ACPE IWG #11

- **UK proposal test procedure**
 - **Confirmation**
 - **Concern**

Confirmation of UK proposal test procedure

Compare "From Standstill test"

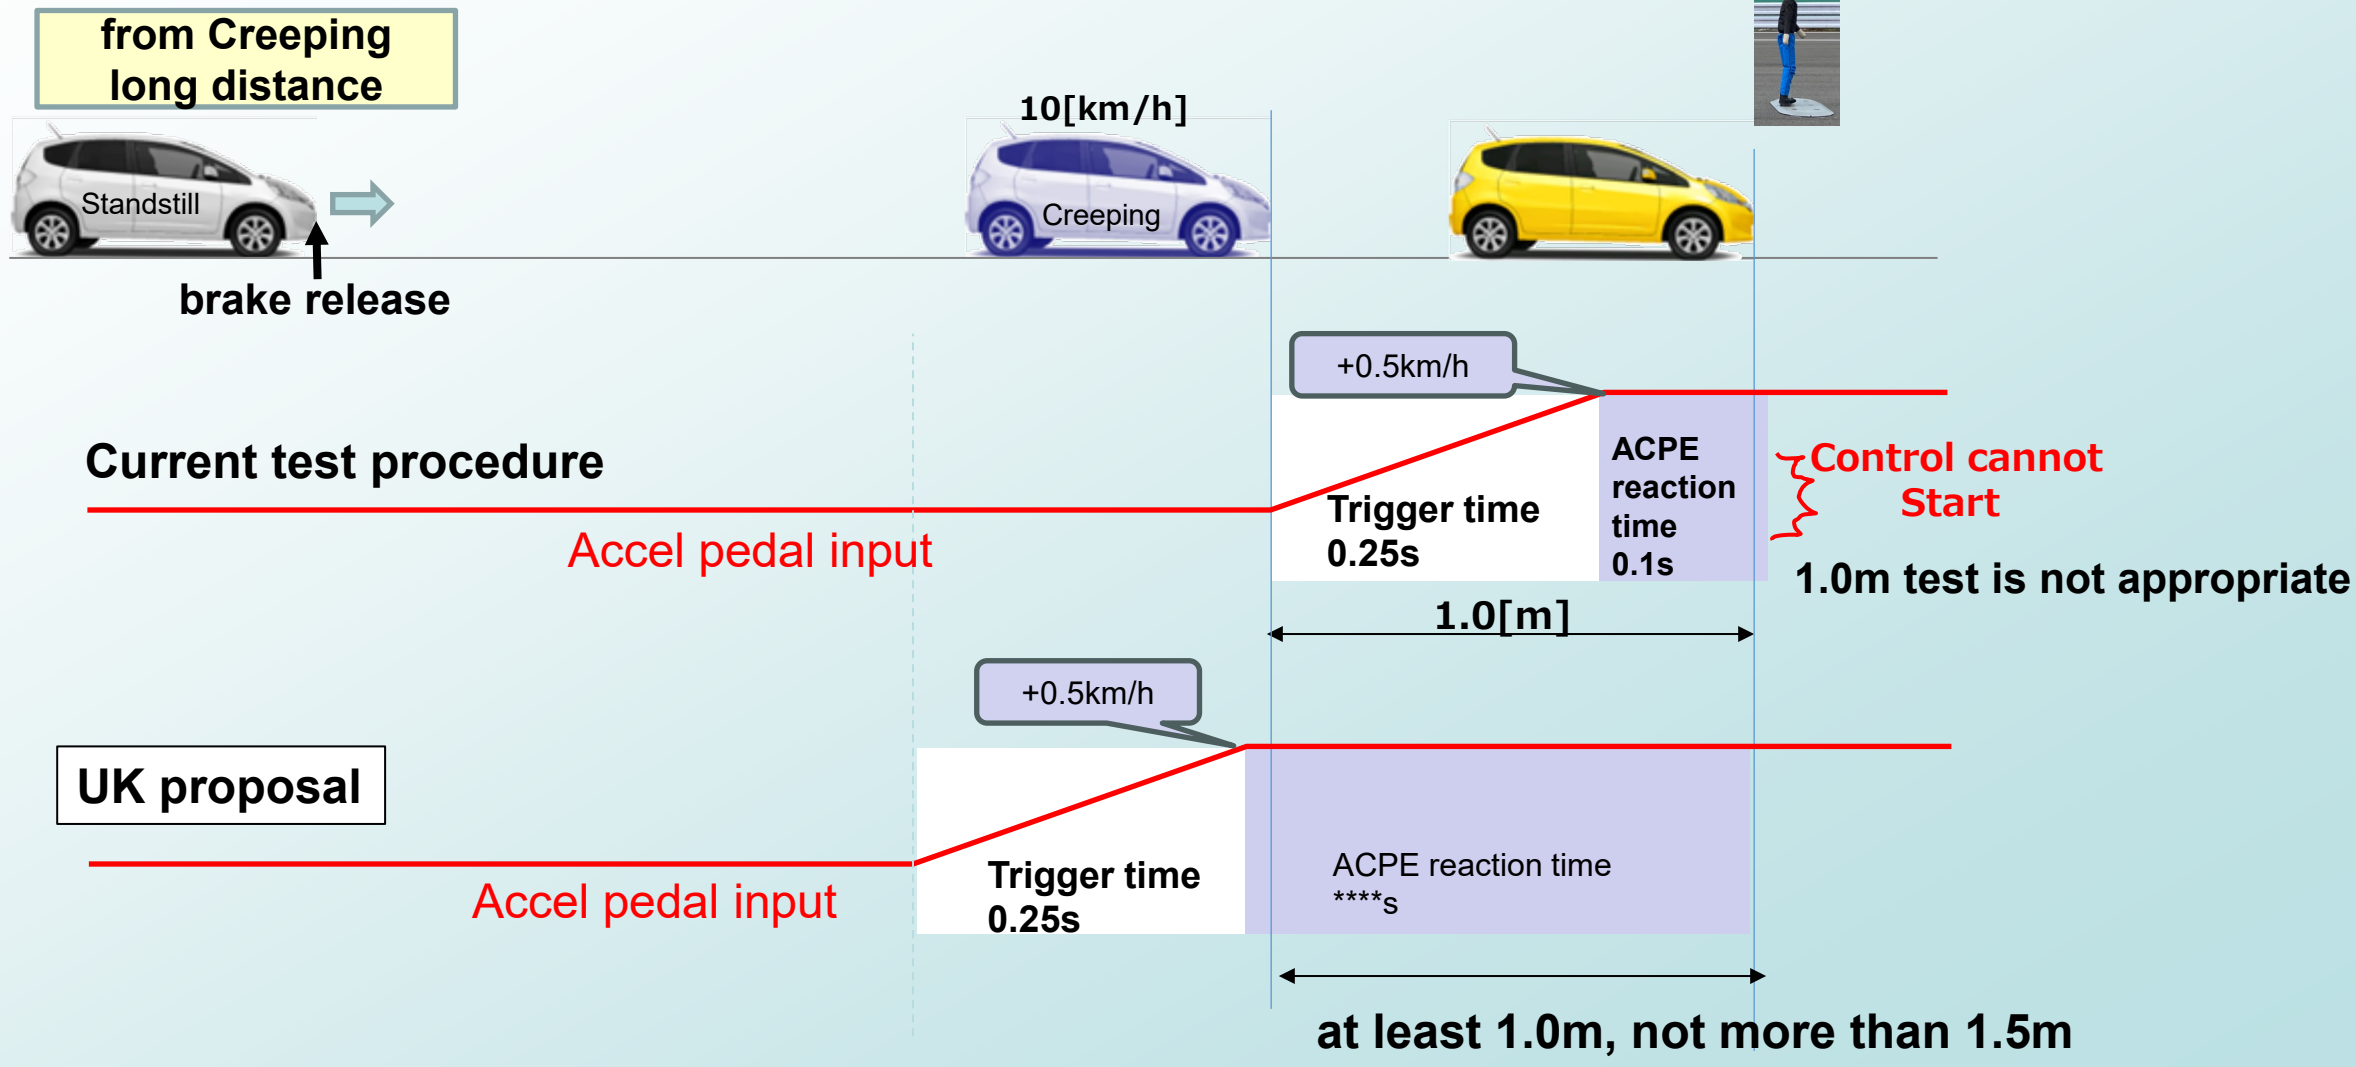
Compare test procedure

Concern of Ultrasonic sensors detection performance

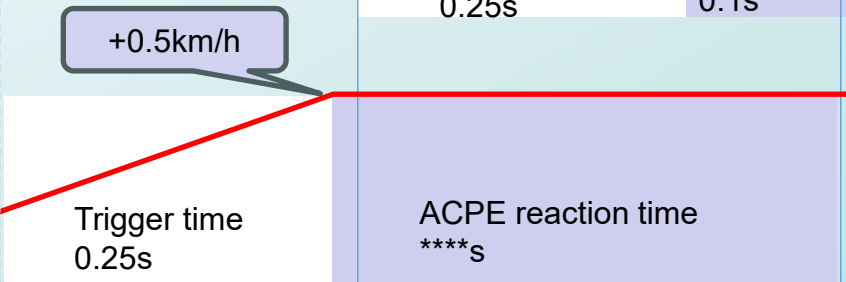
- **System configuration ; most of system is using only “Ultrasonic sensors”**
- **Sensor characteristics ; When the speed increases, it is more difficult to detect obstacles than when the vehicle is stationary.**

0.15s (calculation cycle)

detection interval

The problem remains the same even if B=1.5m

<Lack of robustness and detection reliability>
 Sonar reflection is weak and unstable
 → ACPE can only get weak reflection 2 or 3 times

■ Proposal for Creeping “Rearward” test

- Creeping test will be conducted at **speed less than 4km/h**

The magnitude of ΔV at Distance B

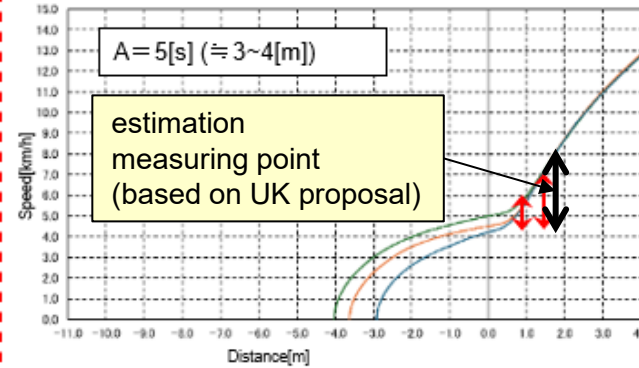
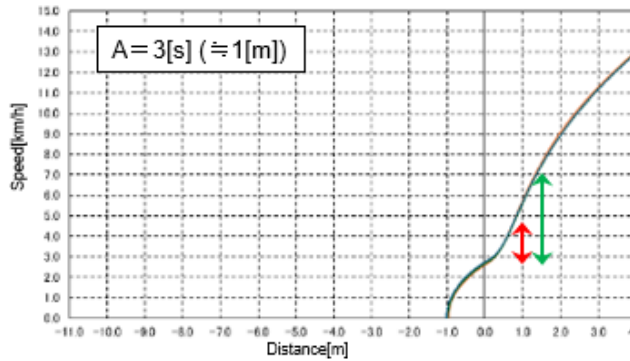
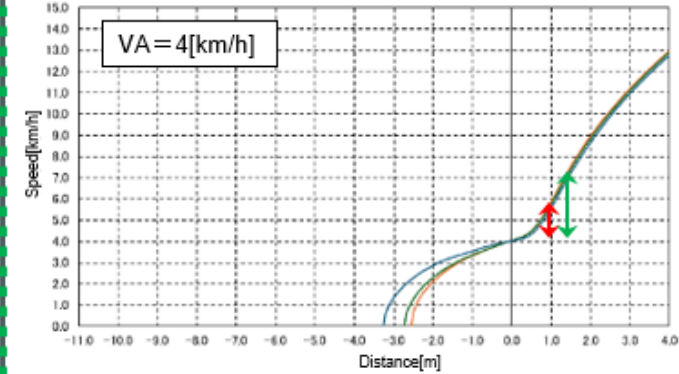
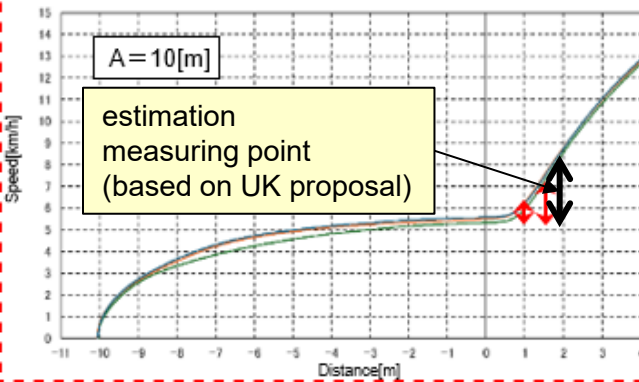
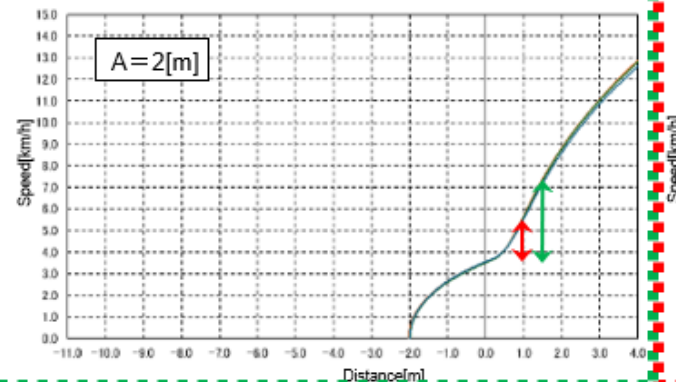
✗ The red arrow indicates $\Delta V < 3\text{km/h}$.

Distance A is short

Distance A is long

Distance A is defined by time

Distance A is defined by distance

To increase ΔV , it is better to shorten distance A and lower VA. And Distance B=1.0m is not suitable for evaluation.

Speed increase without ACPE operation is small at long distance creeping run
